ADDENDUM

PROJECT #:	CAP 2024	ADDENDUM #:	3
		DATE OF ISSUE:	March 15, 2024
PROJECT NAME:	Landscape Construction and Maintenance	ISSUED BY:	Trevor Reeder
		PAGE(S):	2

This addendum is issued to include the following:

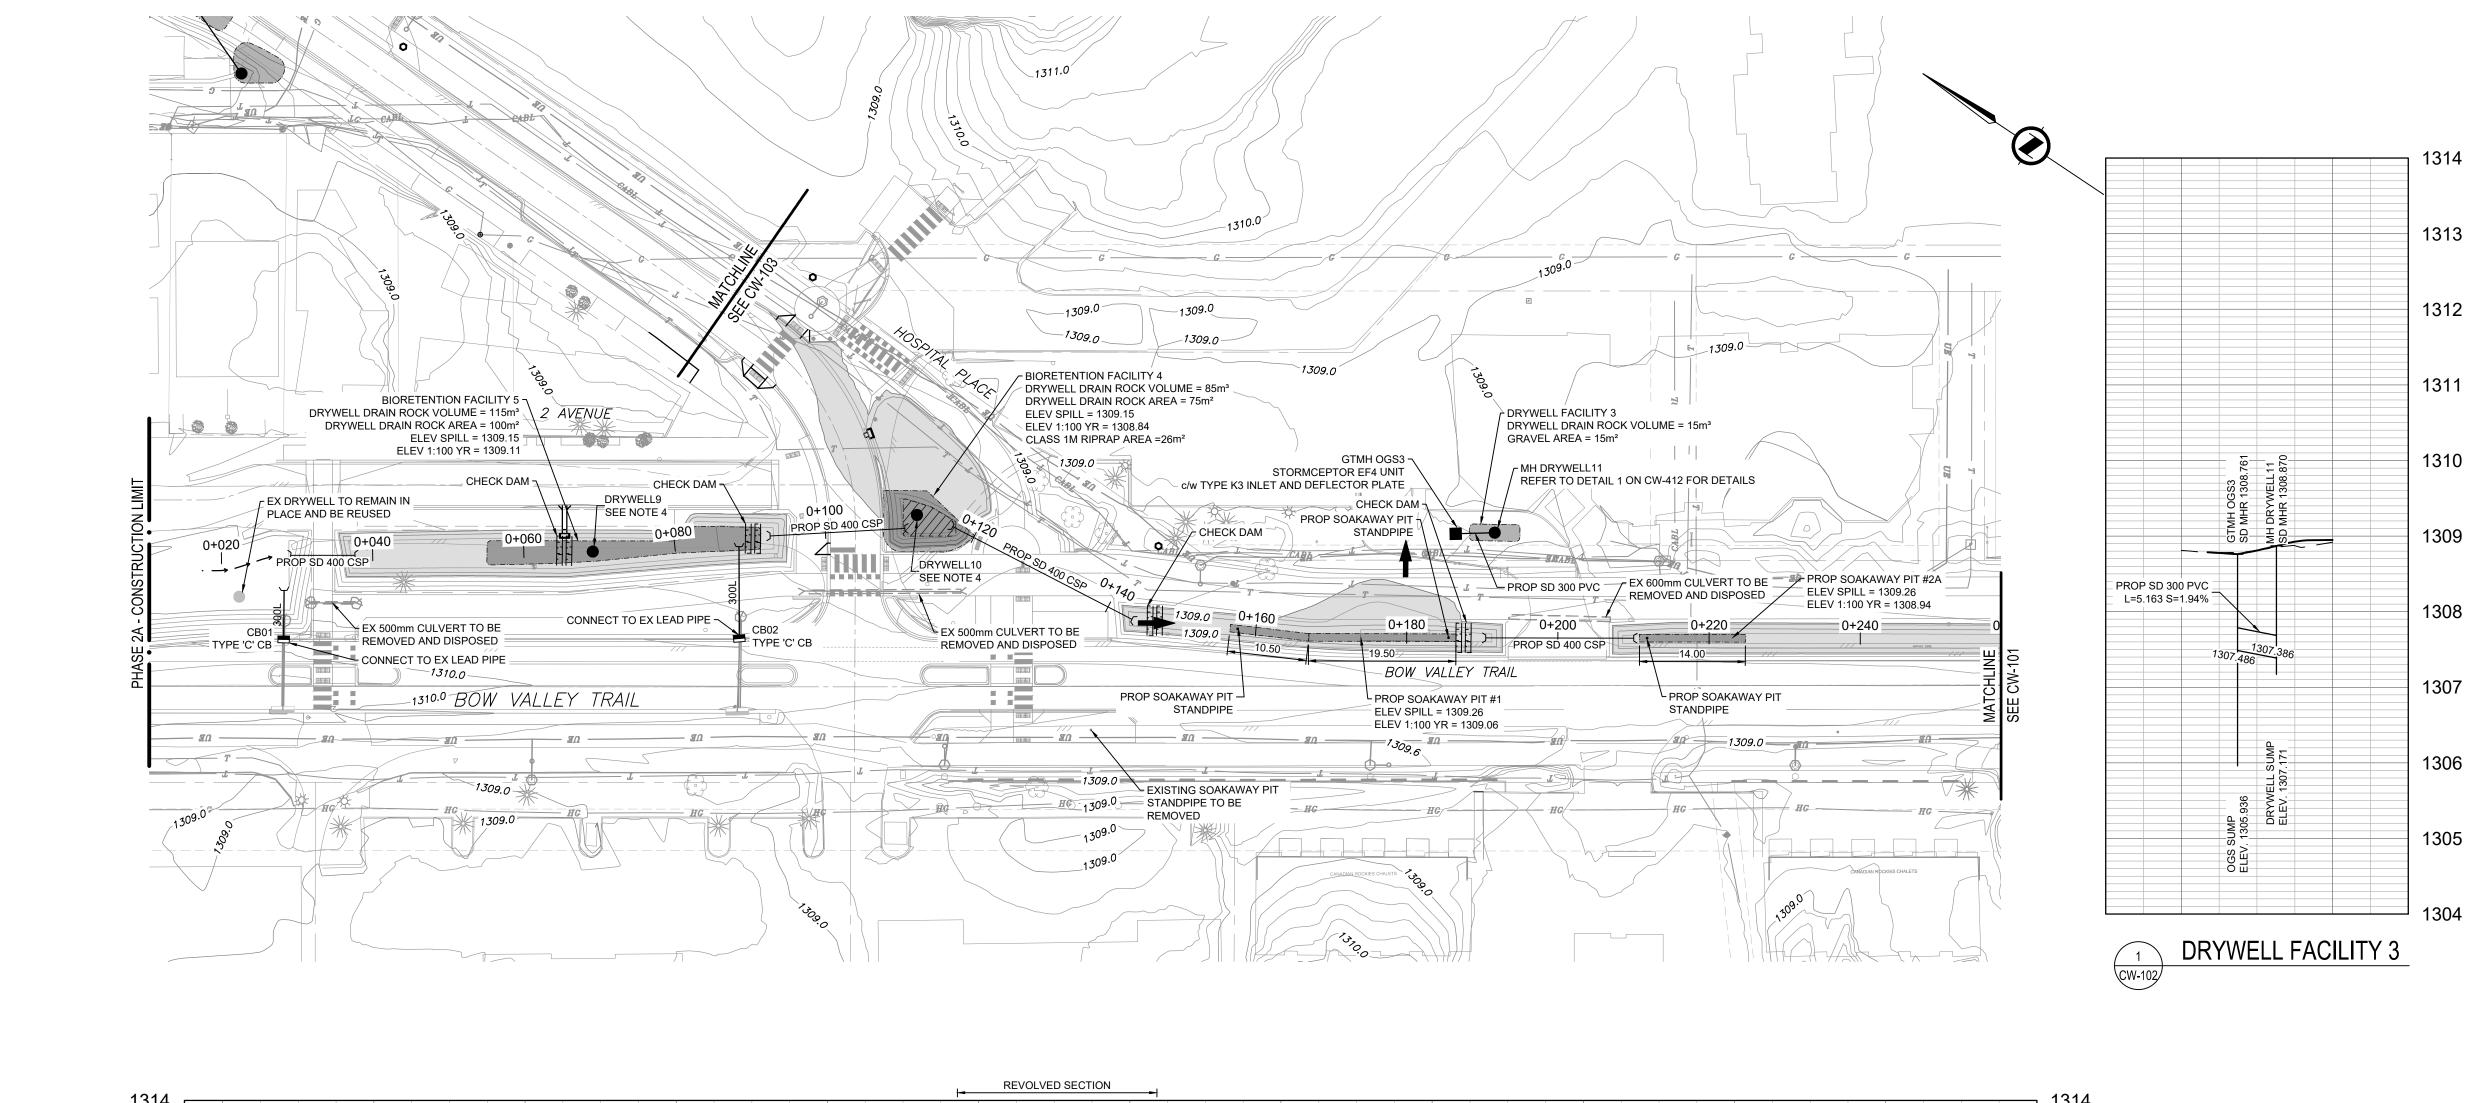
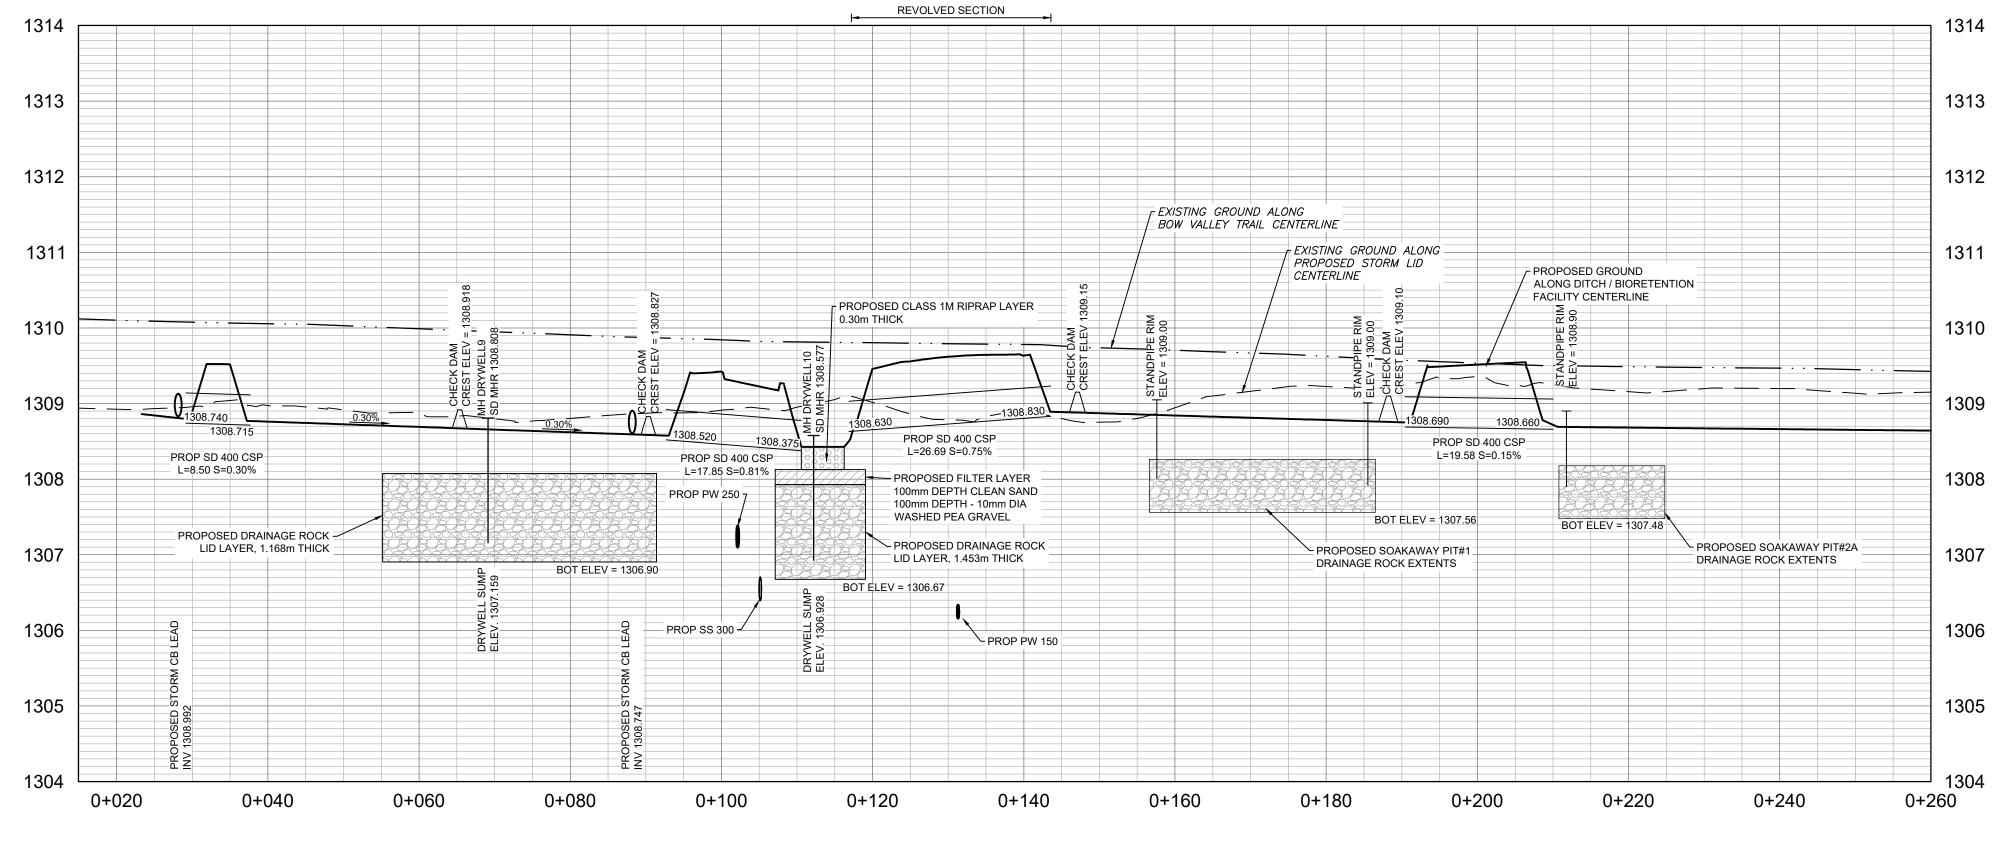
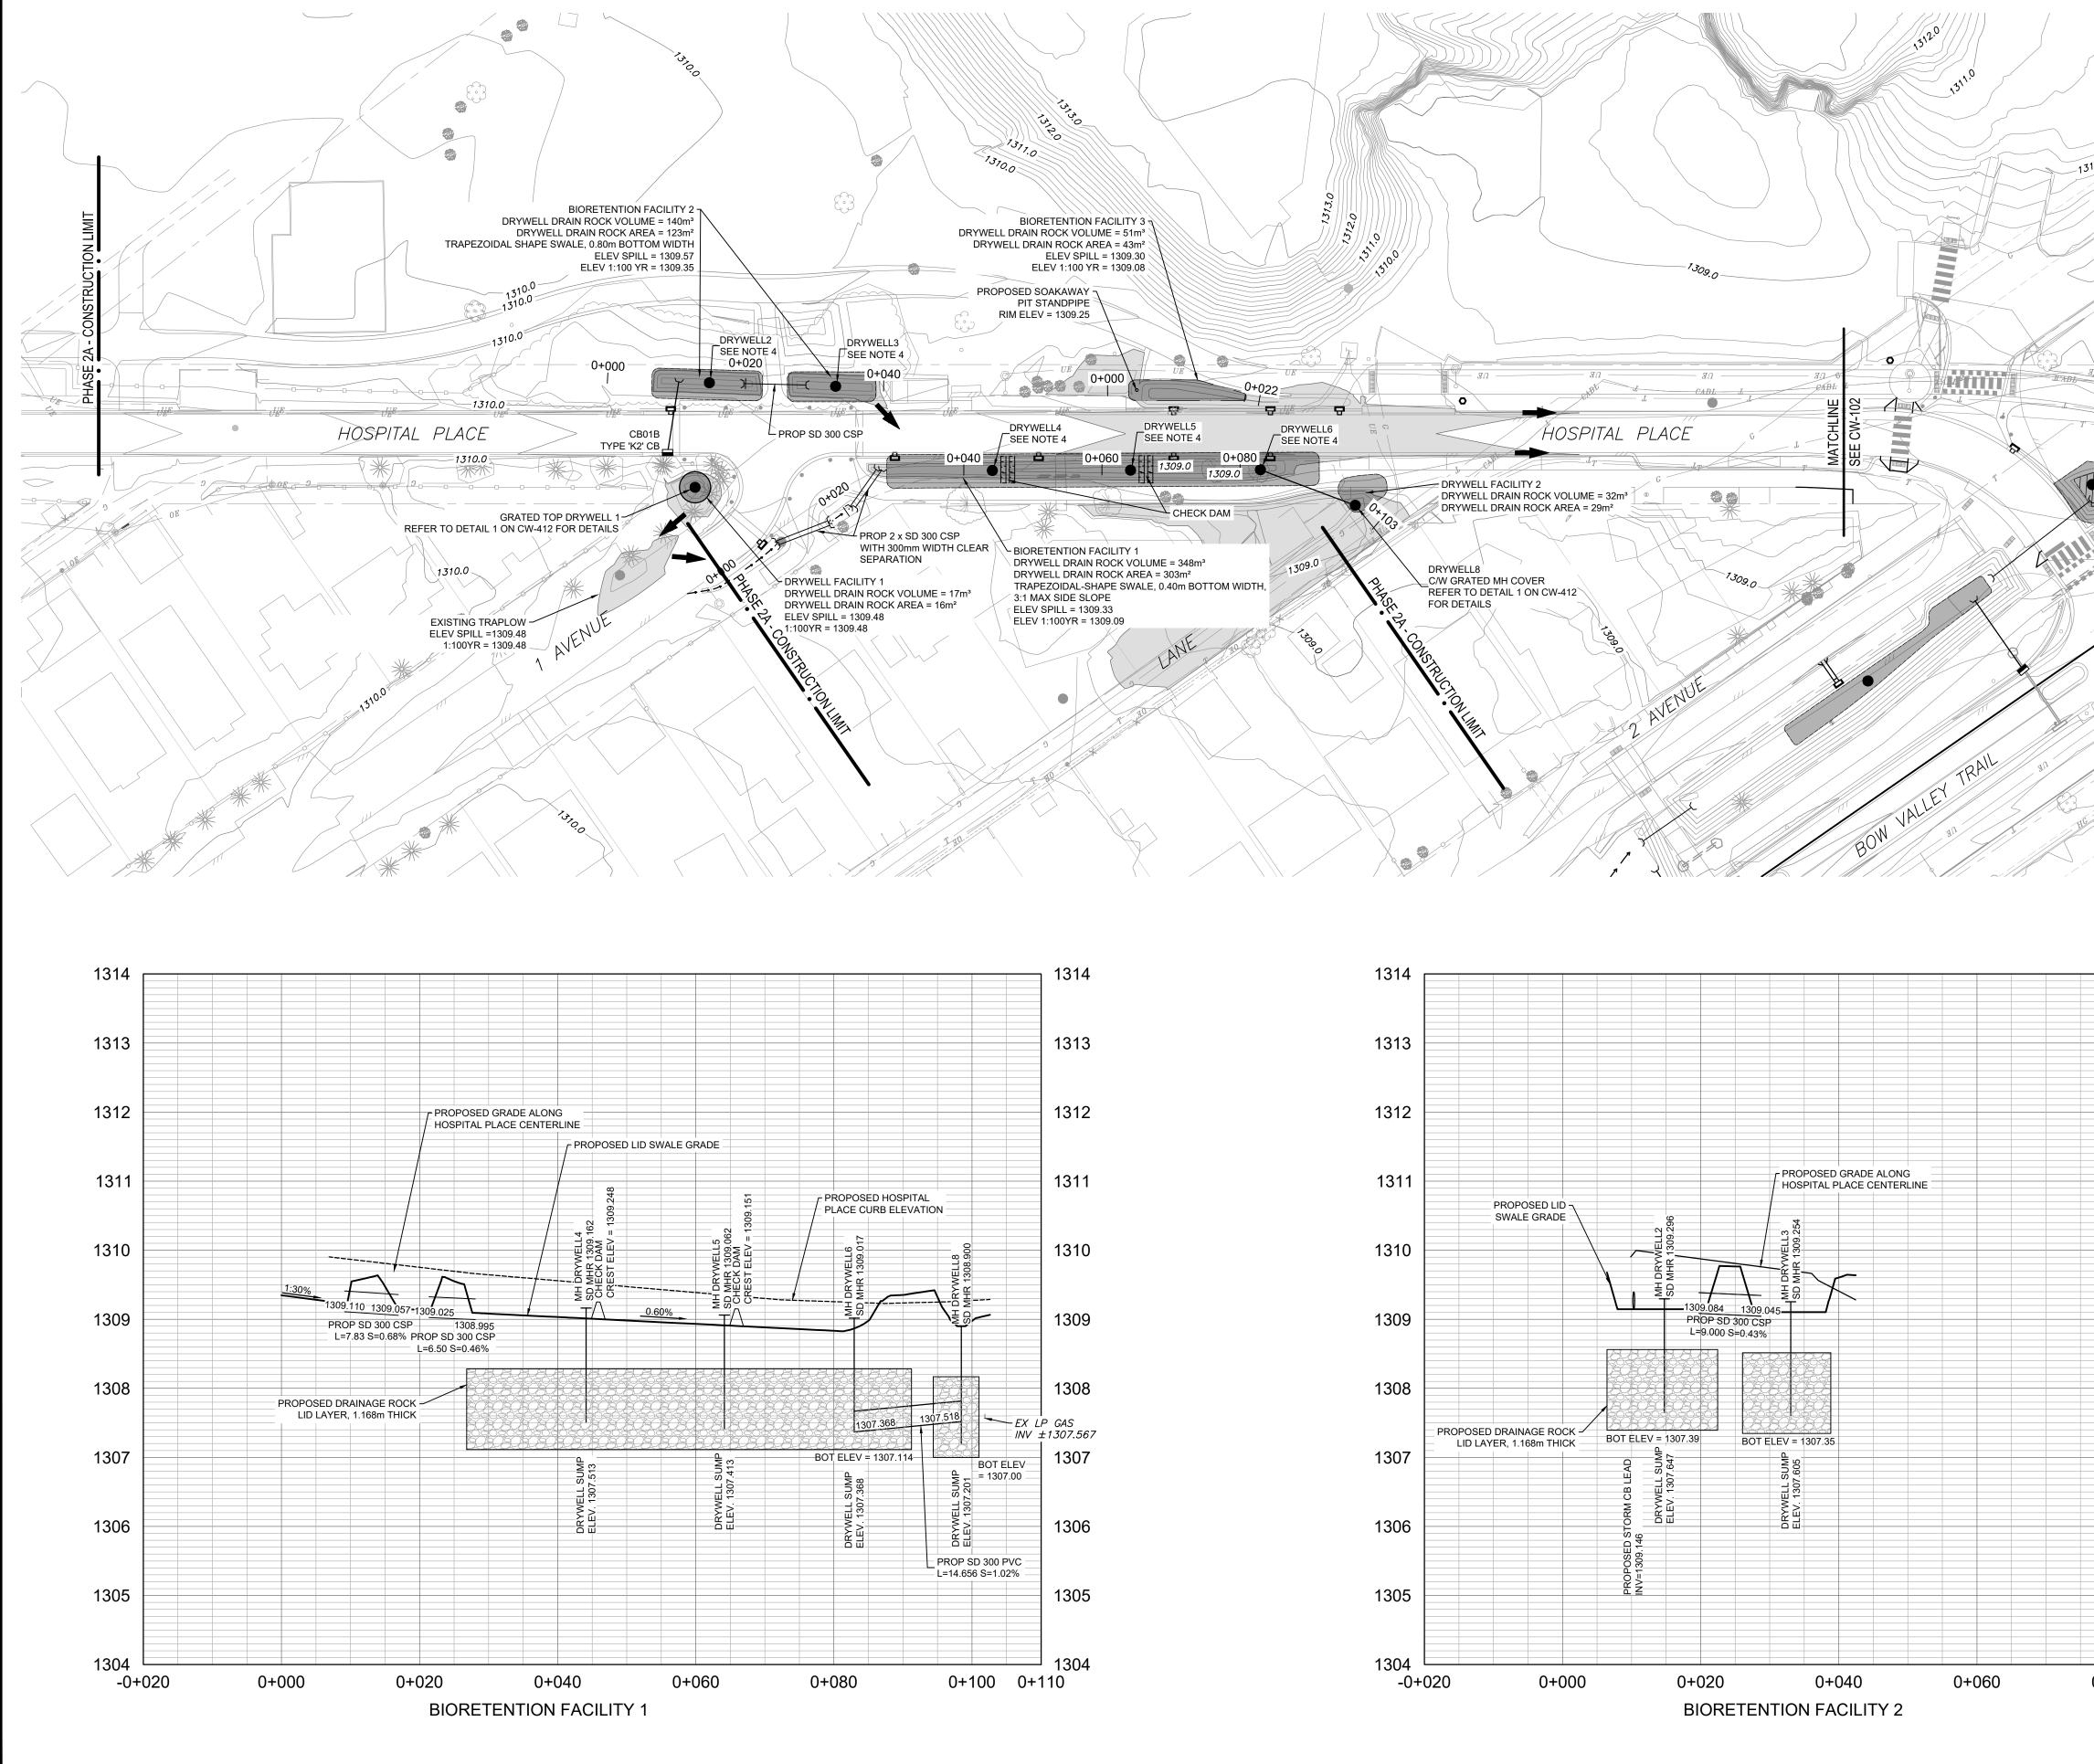
RFI No.	RFI and Res	ponse					
1.	Question:	Will all work by others include excavation by others, supply and install materials by others and Landscape Contractor to follow behind to complete contract items or is the work by others completed and buried requiring the Landscape Contractor to excavate and expose completed work?

Response:	The anticipated extents of the work by others will include supply and installat of soakaway pit drainage rock and earthworks to accommodate construction surface works adjacent to these areas. Minor excavation by the Landscape Contractor may be necessary to expose the filter fabric drainage rock that is be removed. Minor rough grading by the Landscape Contractor may be necessary to shape the subgrade prior to installation of soils and LID materia Refer to Attachment 1 for Stormwater Plan Profile drawings showing the anticipated location of soakway pit drainage rock (for information).
